Application No. 10/802,385  
Amendment Dated October 12, 2006  
Reply to Office Action of April 12, 2006

**Amendments to the Drawings**

Fig. 1

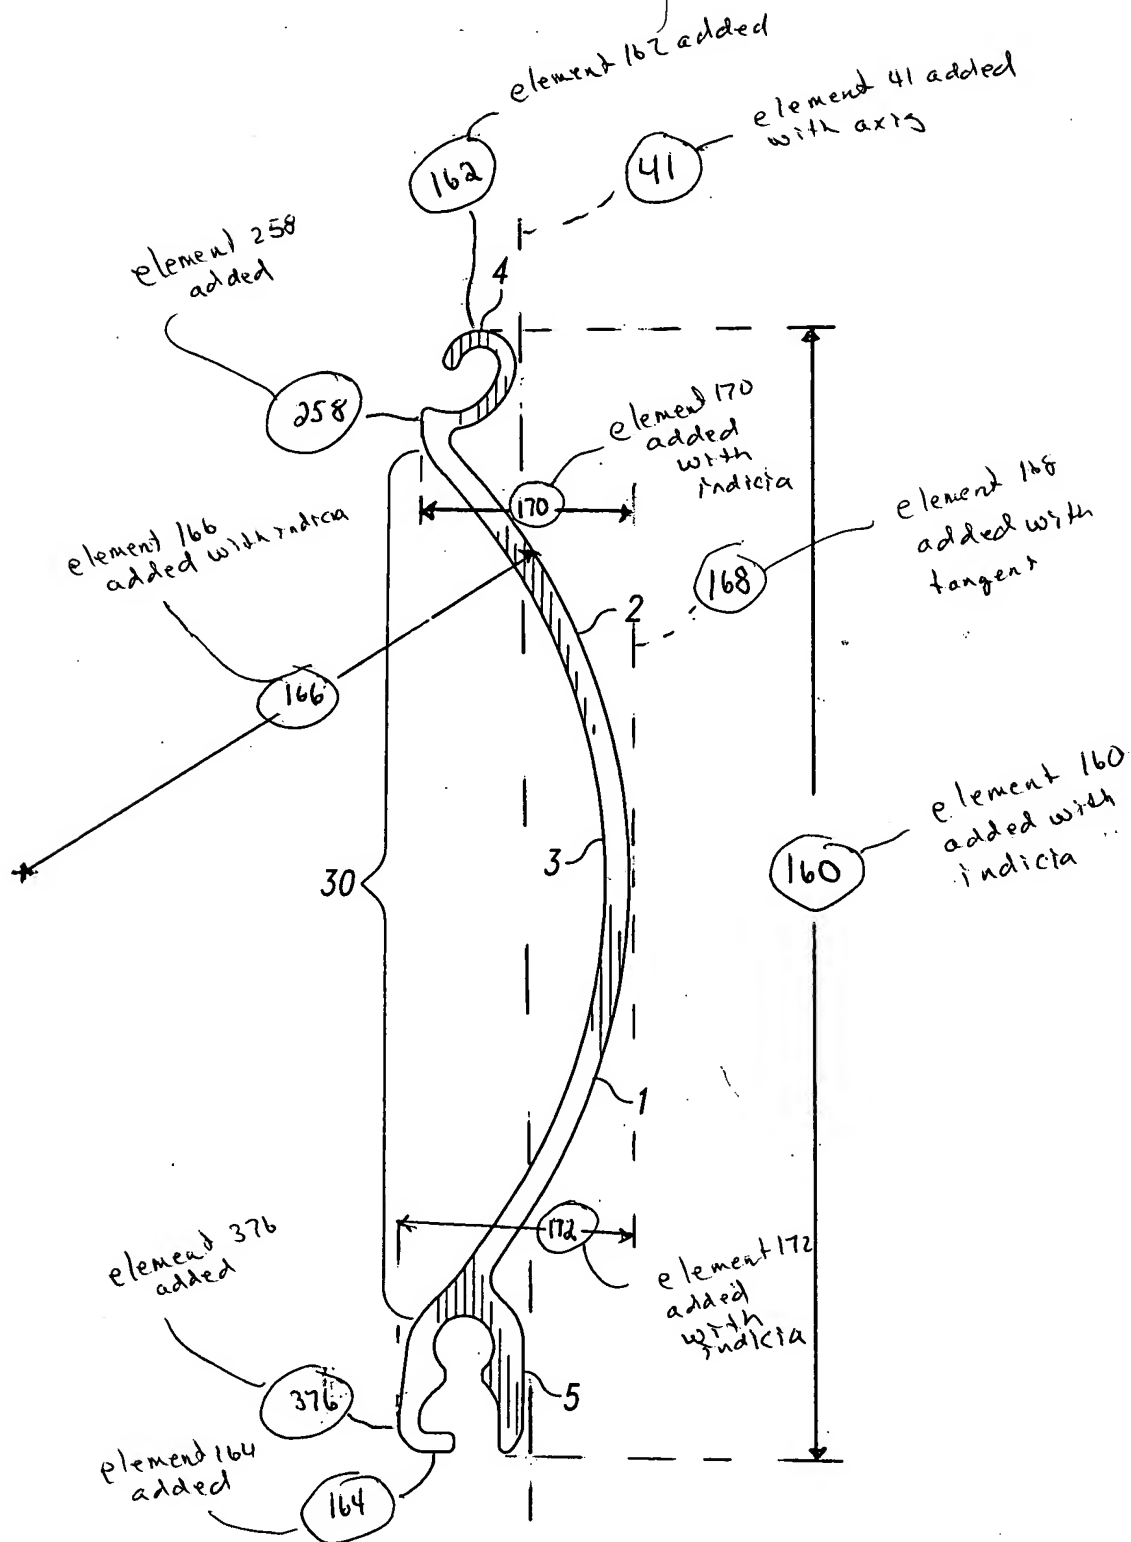
The attached three sheets of drawings include changes to Figs. 1-3 to bring them more closely into conformity with Figs. 1-3 as originally filed in this application. These three sheets which include Figs 1-3 replace the two formal drawing sheets submitted herein on September 2, 2004 that included Figs. 1-3 which replaced the one sheet containing Figs. 1-3 originally filed in this application. Reference numerals, lead lines and other indicia have been added to the drawings to allow the specification to be amended to describe the information originally present in Figs. 1-3 of this application.

The amendments to the drawings provide reference numerals, lead lines and other indicia to support recitation of the material disclosed in Figs. 1-3 as originally filed in this application.

Fig. 2

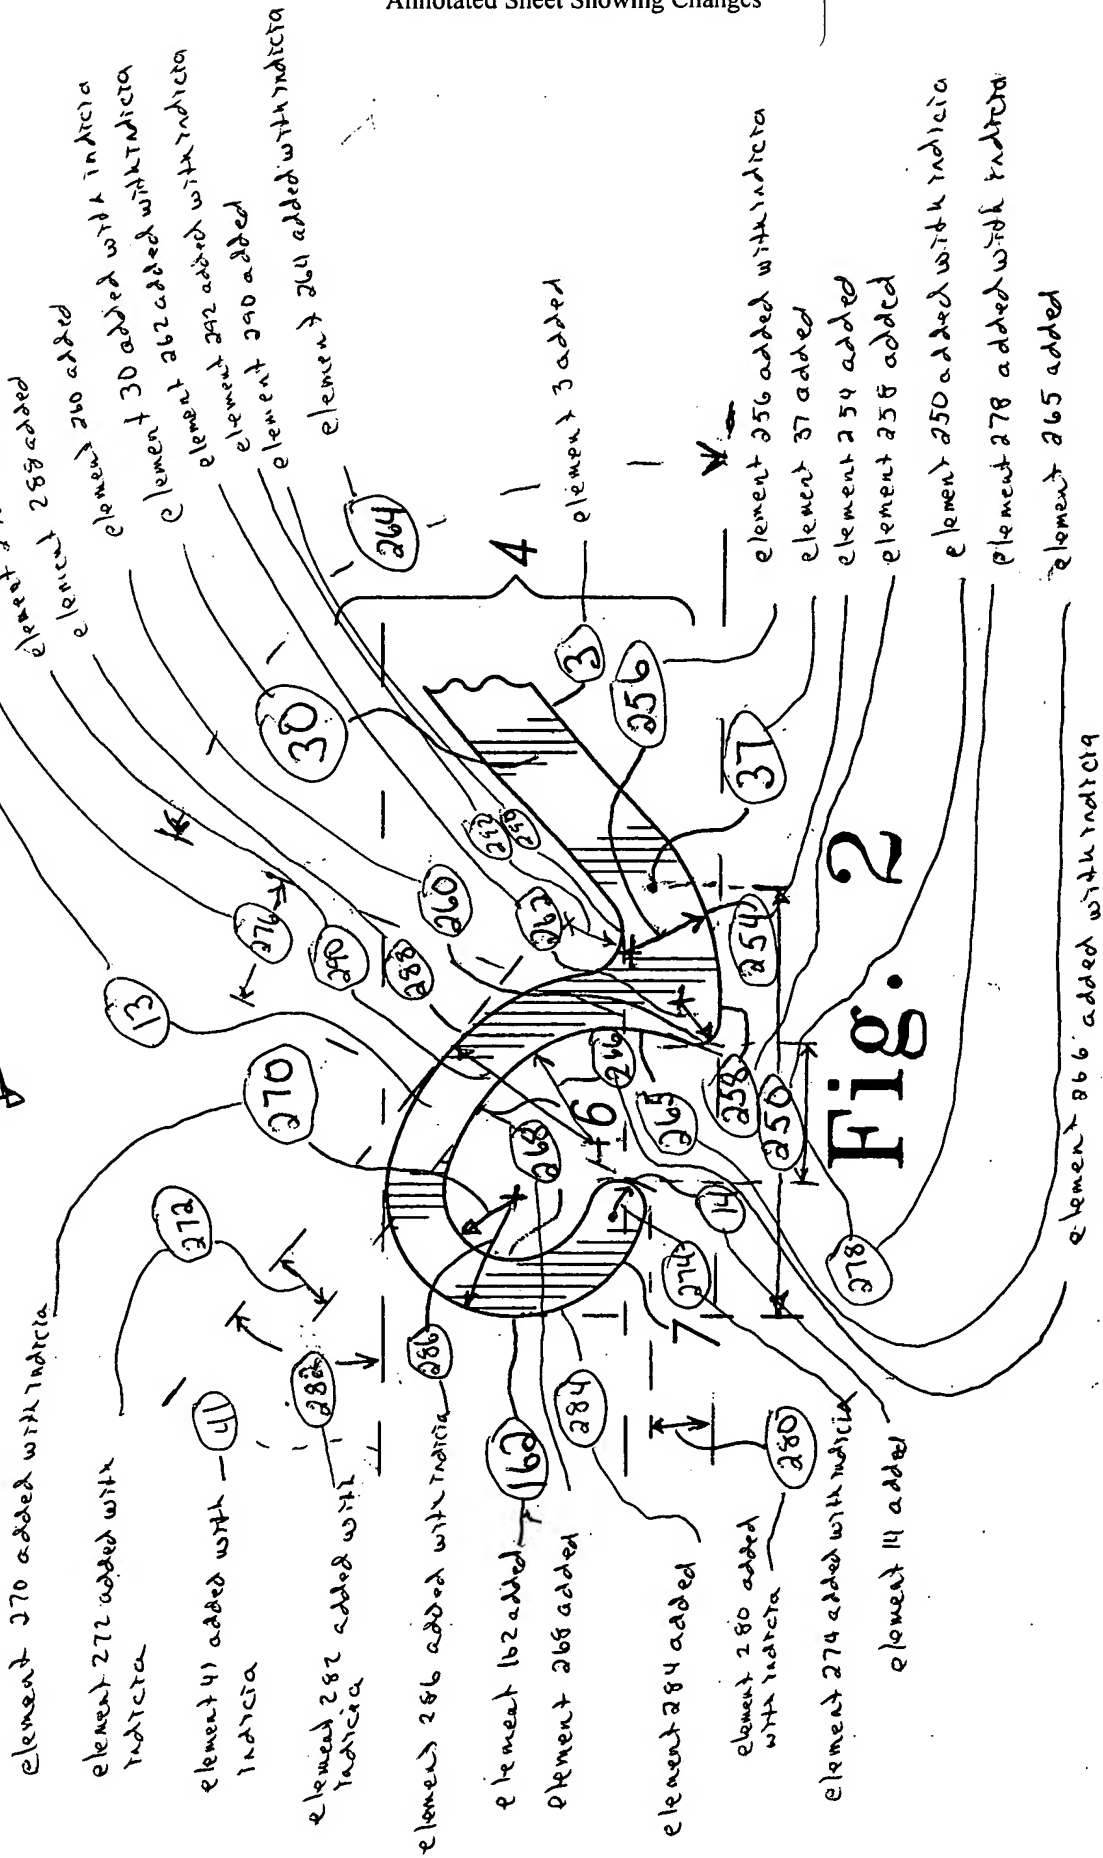
A substitute specification has been submitted which includes an amendment to correct a scrivener's error in the Brief Description of Figs. 2 and 3 to have the Brief Description conform to the Detailed Description that consistently refers to Fig. 2 as showing an engaging track and Fig. 3 as showing a receptacle track and to recite information clearly shown in Figs. 1-3 as originally filed. The annotated specification shows additions as double underlined material and deletions as strikethroughs.

Fig. 2 placed on separate sheet copied  
at higher magnification and reoriented
